325 Whale Beach Road, Palm Beach

Updated Plans

Proposed Changes

Comments on Updates to Plans

SITE PLAN – showing test locations

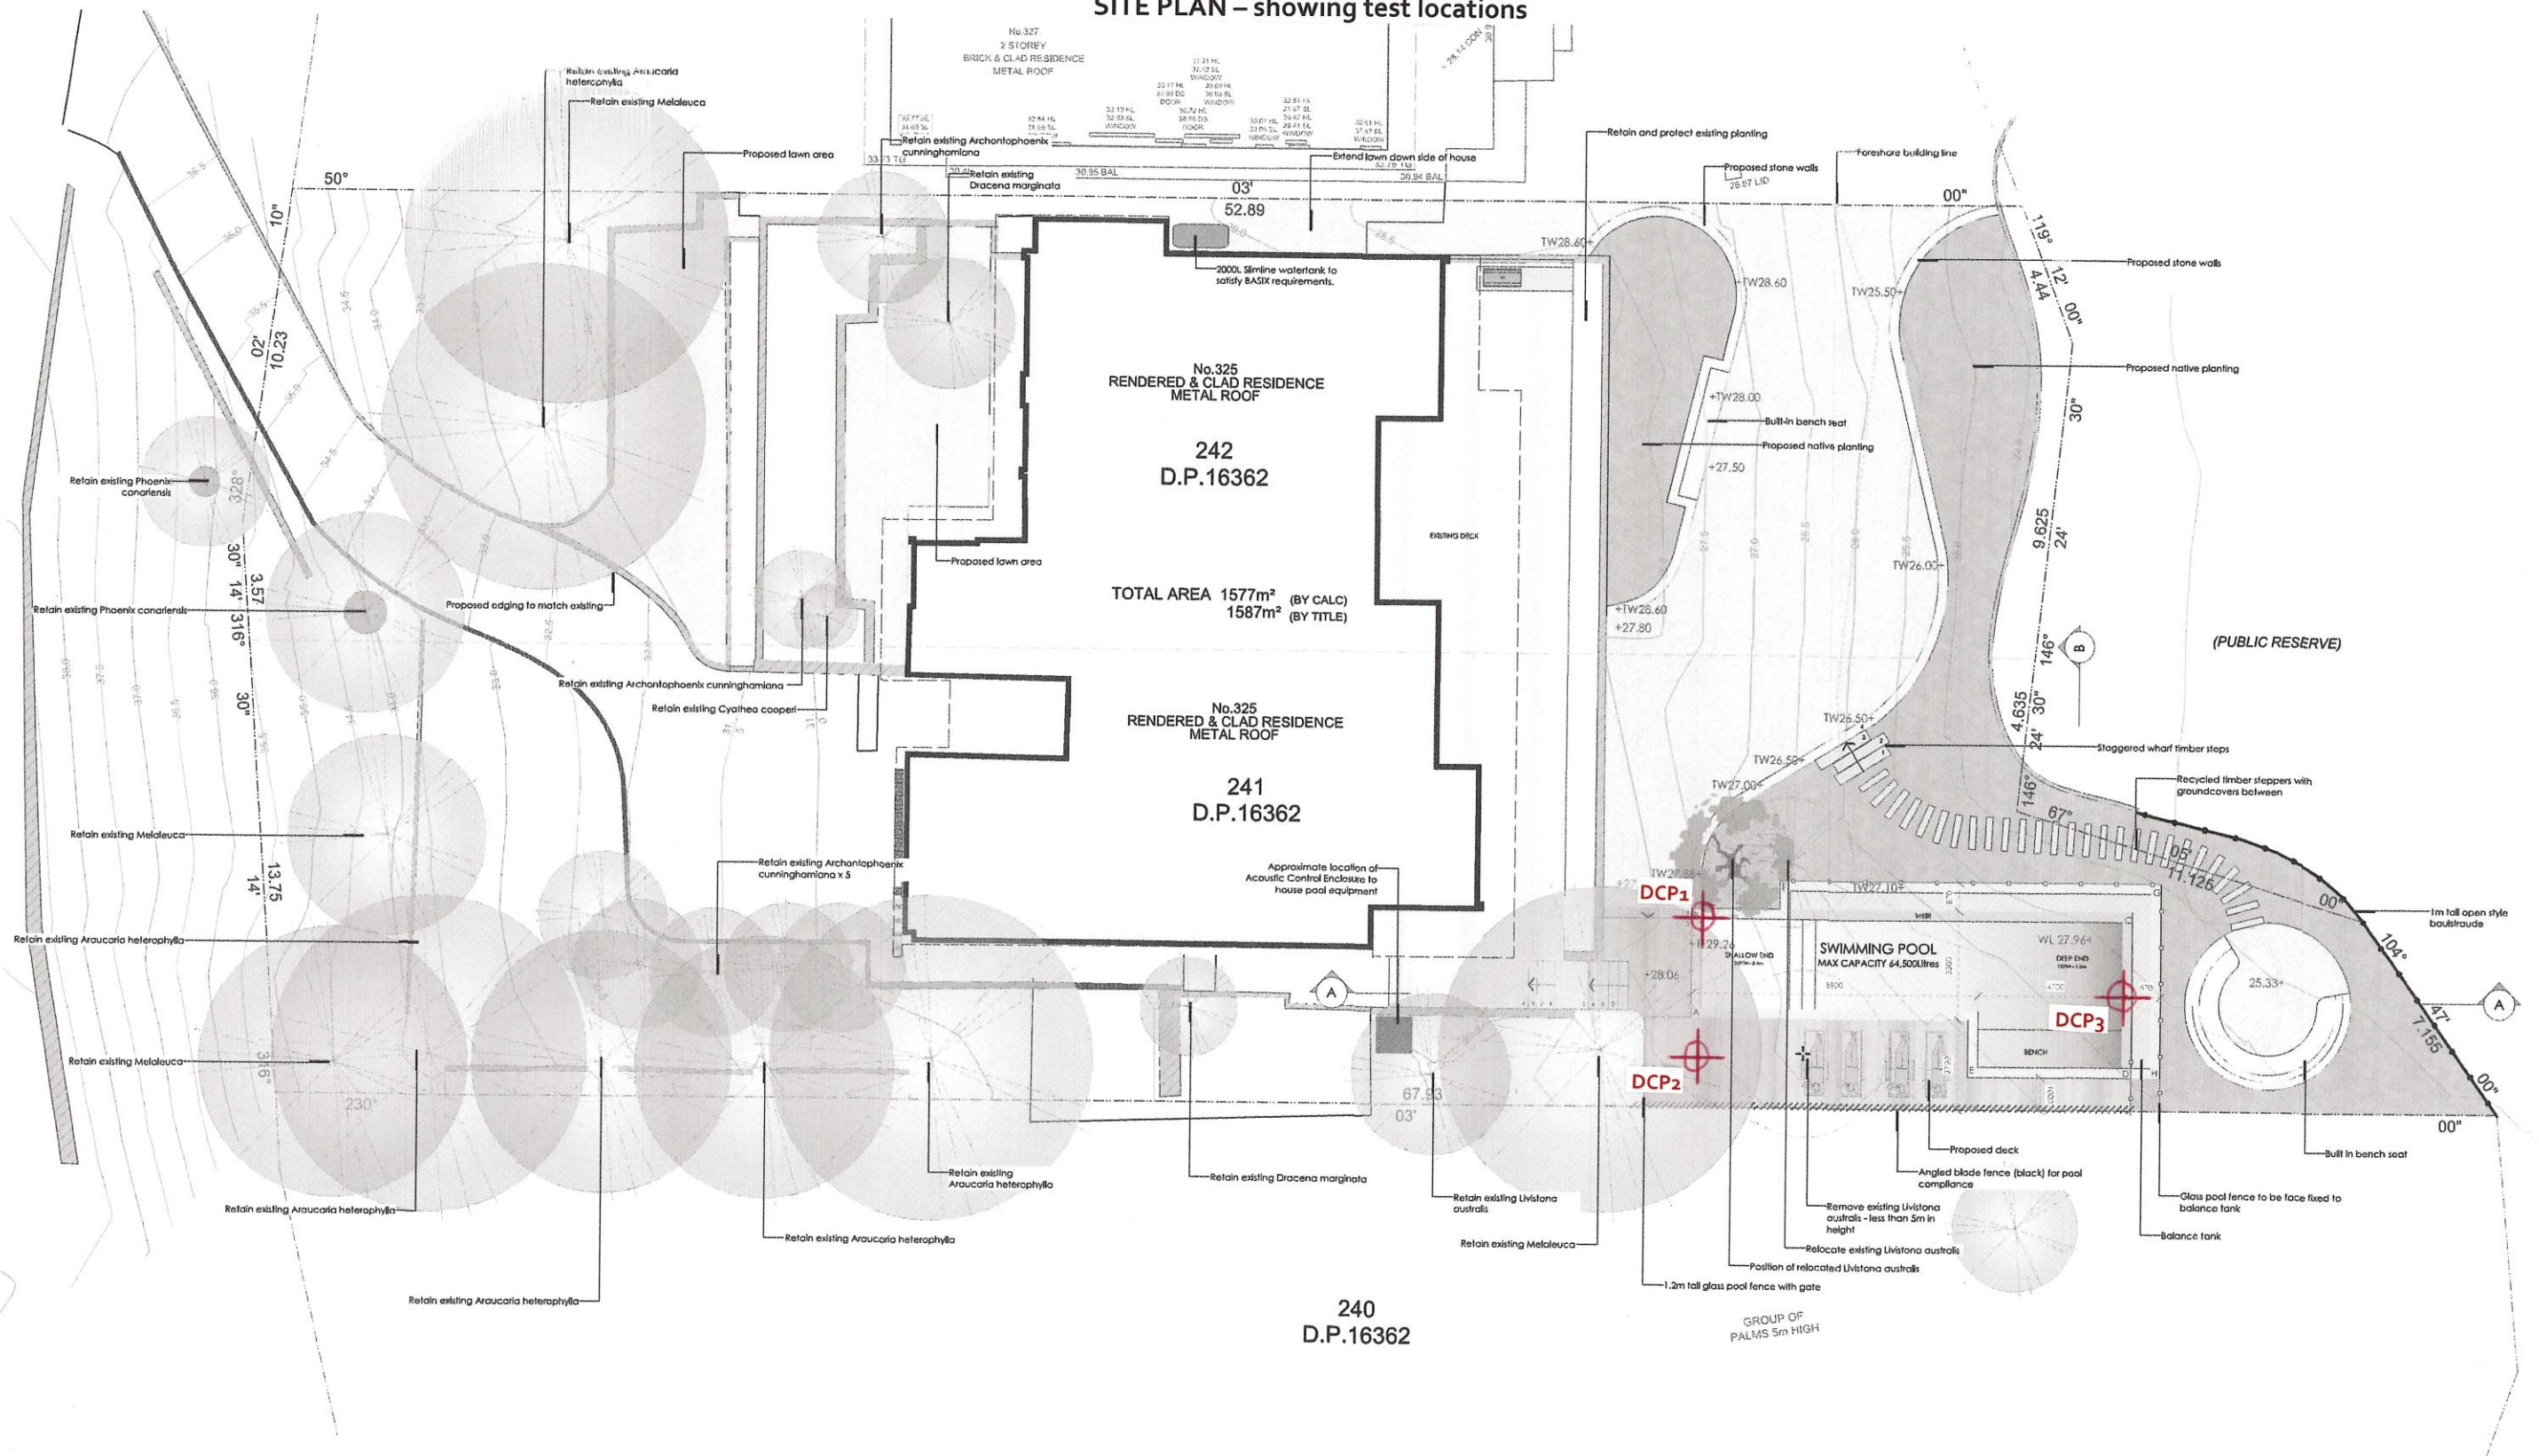
Council have requested additional information on the proposed retaining walls that reach a maximum height of ~1.3m on the downhill side of the property. They are shown on LMP01. As such we would add the following advice to the existing report, where the advice contradicts that in the existing report, it supersedes it:

Two fills will be placed on the downhill side of the property for landscaping. No fills are to be laid until retaining walls are in place. The fills will reach a maximum depth of ~1.3m. The surface is to be prepared before any fills are laid by removing any organic matter and topsoil. Fills are to be laid in a loose thickness not exceeding 0.3m before being moderately compacted. Tracking the machine over the loose fill in 1 to 2 passes should be sufficient. Immediately behind the retaining walls (say to 1.5m), the fills are to be compacted with light weight equipment such as a hand-held plate compactor so as not to damage the retaining

walls. Where light weight equipment is used, fills are to be laid in a loose thickness not exceeding 0.2m before being compacted. No structures are to be supported on fill.

For cantilever or singly-propped retaining walls, it is suggested the design be based on a triangular pressure distribution of lateral pressures using the parameters shown in Table 1.

It is to be noted that the earth pressures in Table 1 assume a level surface above the wall, do not account for any surcharge loads, and assume retaining walls are fully drained. Ground materials and relevant earth pressure coefficients are to be confirmed on site by the geotechnical consultant.

All retaining walls are to have sufficient back-wall drainage and be backfilled immediately behind the wall with free-draining material (such as gravel). This material is to be wrapped in a non-woven Geotextile fabric (i.e. Bidim A34 or similar), to prevent the drainage from becoming clogged with silt and clay. If no back-wall drainage is installed in retaining walls, the likely hydrostatic pressures are to be accounted for in the structural design.

Retaining wall footings for terracing can be supported on the firm to stiff clays of the natural profile. A maximum allowable bearing pressure of 200kPa can be assumed for footings on firm to stiff clays.
